Product Change Notification

1. ECR #: 25-36732-1
Notification #: 795

- RPBE- - null
- SCRES - SCRES SEALED CIRCULAR RECEPTACLE
- RPCE - SEAL RECTANGULAR RECEPTACLE, ETHERNET

4. Part #'s Affected

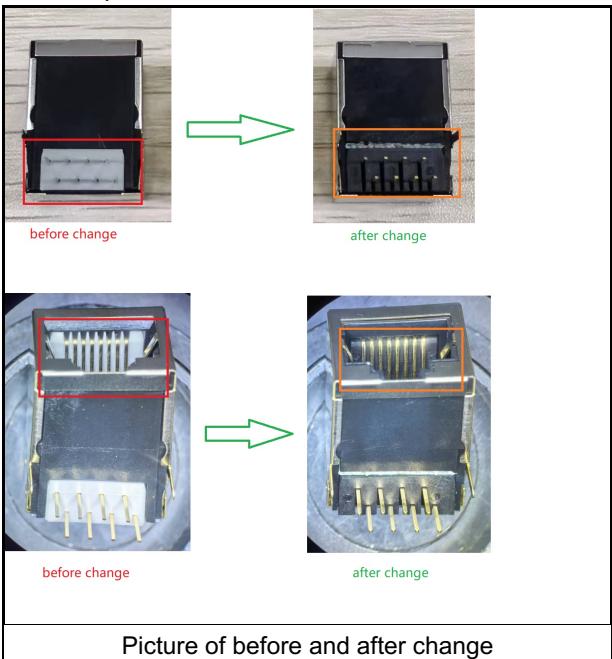
Insert color changed from white to black.

Manual pin insertion of insert replaced by insert molding process to improve manufacturability. This will be a rolling change.

- Form - Insert color change
